802.3cy TX Droop Spec Revisited

September 20, 2022

Introduction

Tx Droop: Non PoDL Case

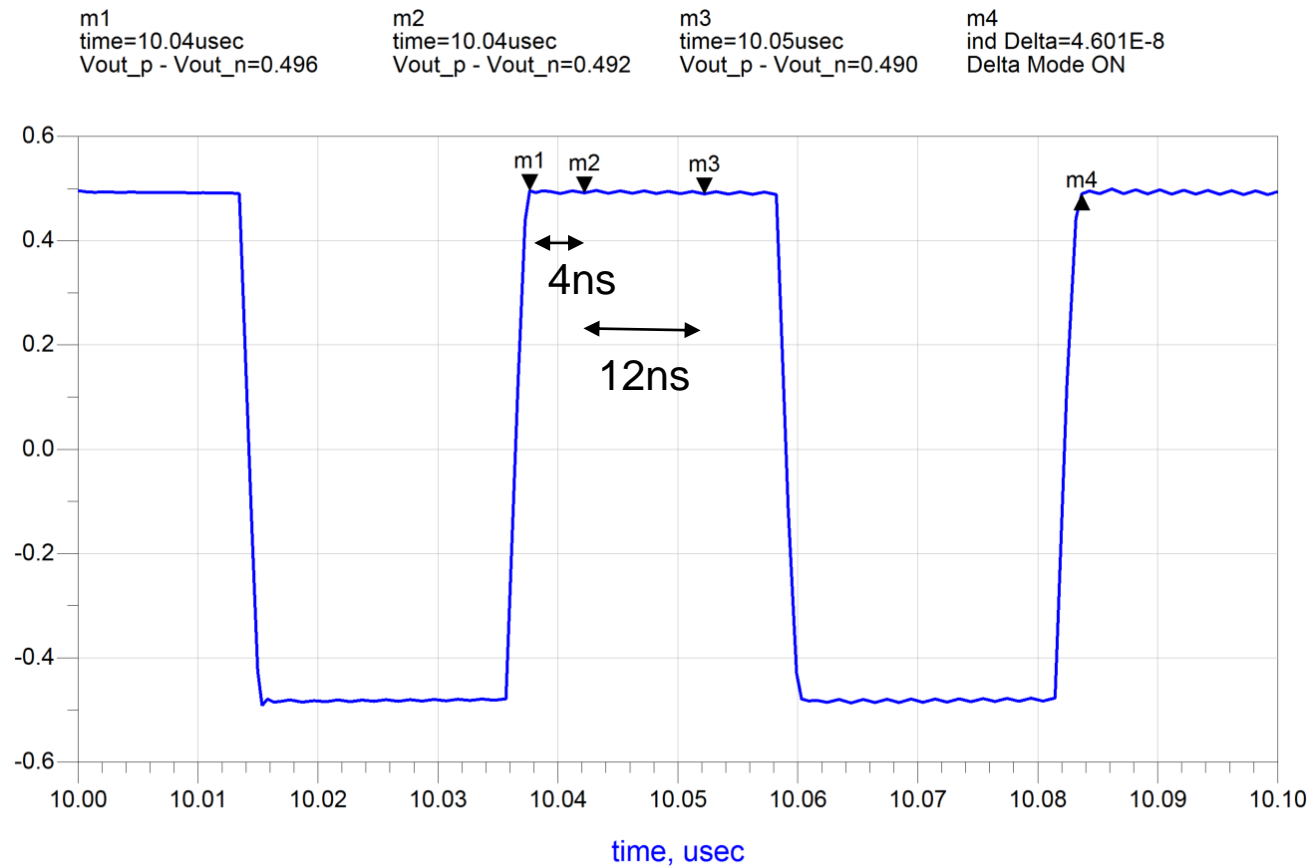
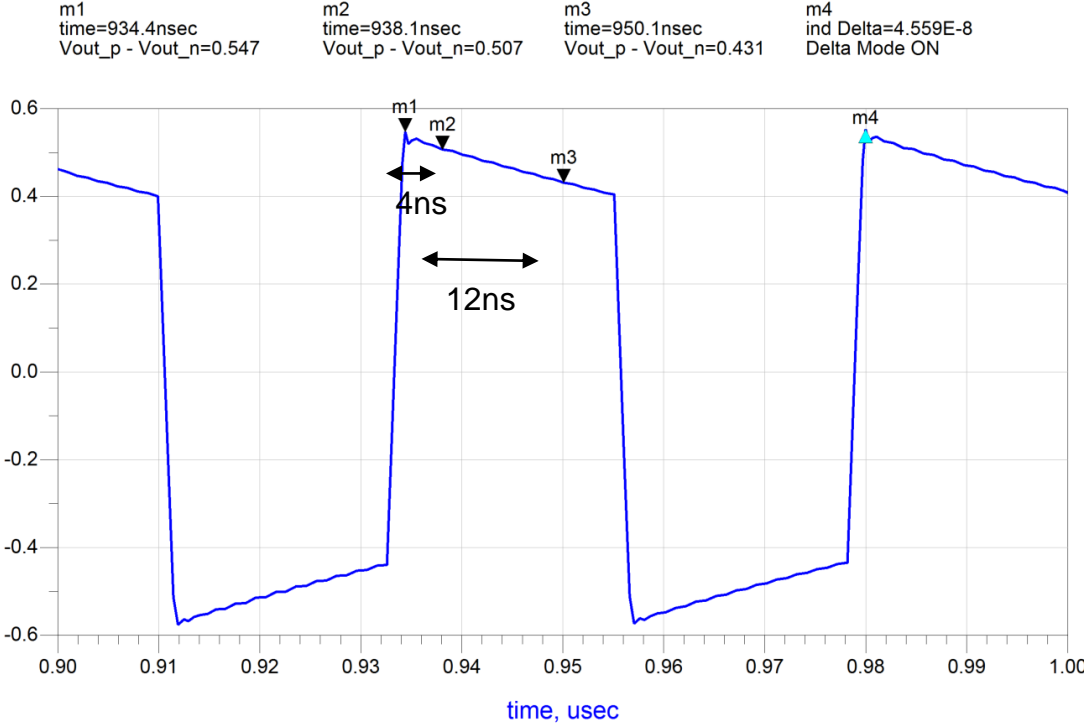
$$\text{Droop} = \frac{Vm_2 - Vm_3}{Vm_2} * 100 \% = 0.4\%$$

Tx Droop: PoDL with L=2uH vs. L=4.7uH

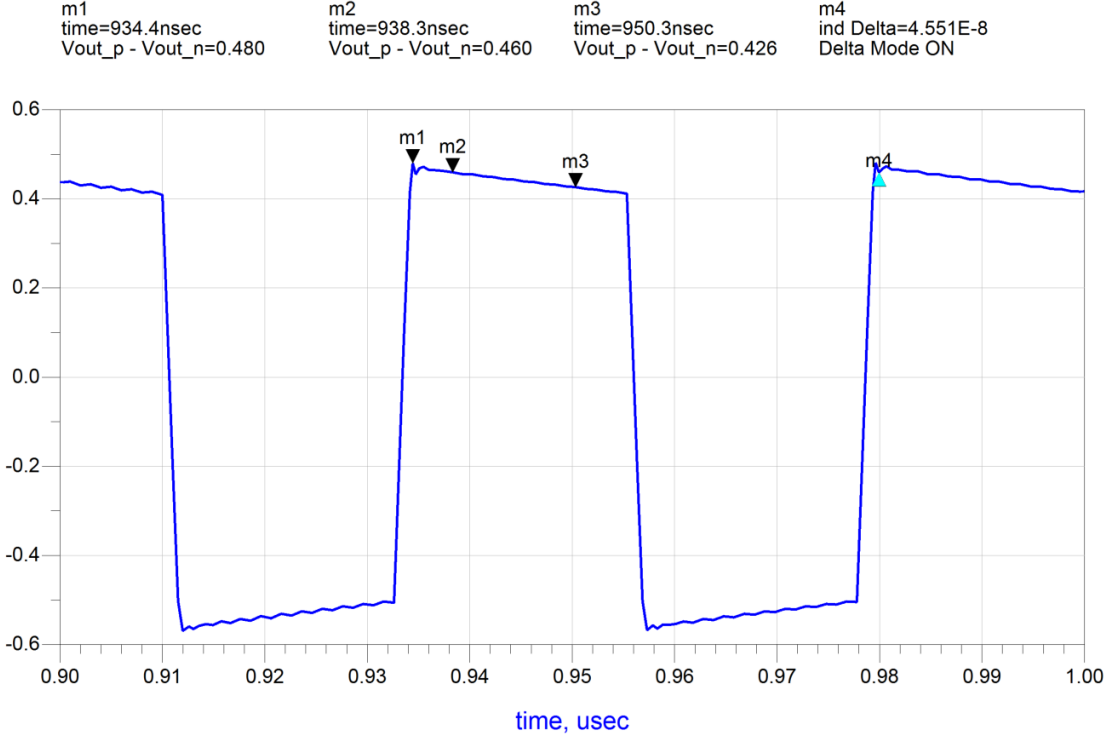
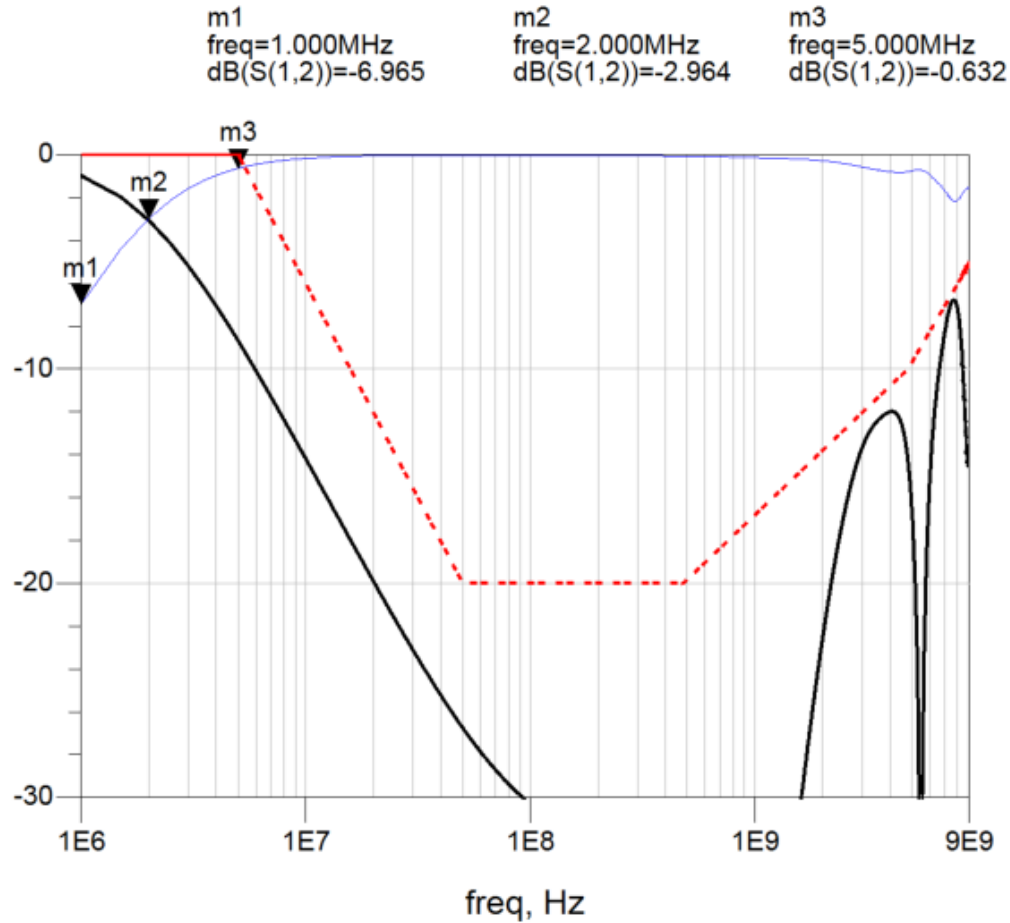
$$\text{Droop} = \frac{Vm_2 - Vm_3}{Vm_2} * 100 \% = 15\%$$

$$\text{Droop} = \frac{Vm_2 - Vm_3}{Vm_2} * 100 \% = 7.4\%$$
